CTA	Ref.:
	System Engineering and On-site Infra Project Meeting	Version: 1.0
		Date: 2017-11-30
		Page: 1/8

Minutes of the Meeting No.1 – 25th July 2018

Figure 28: SAS Safety architecture schema

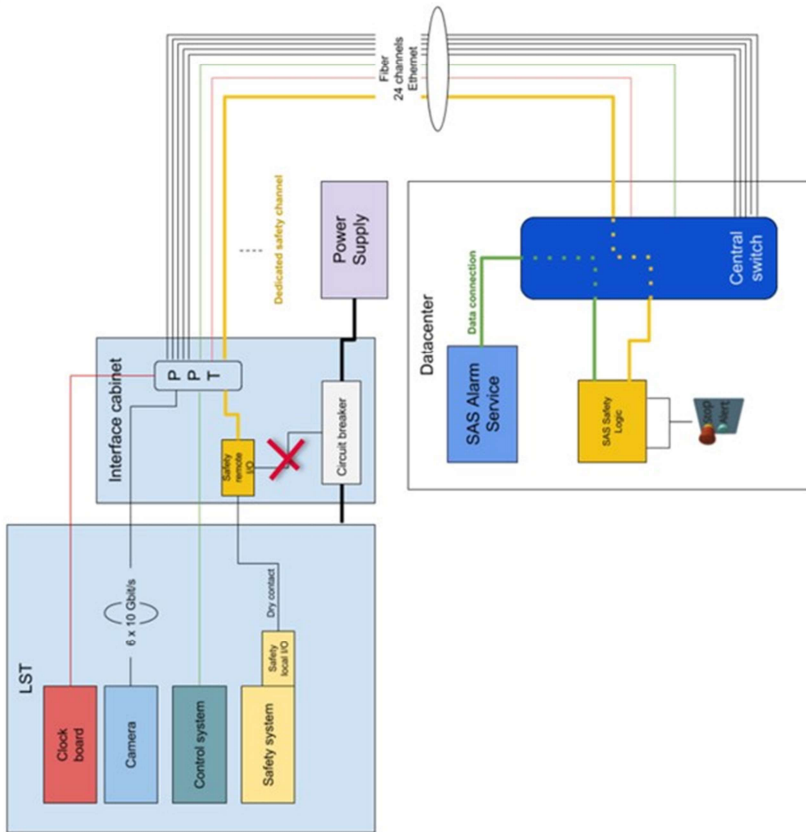
NOTE: See Attached diagram of Array Stop function provided by GT

Array Stop Function
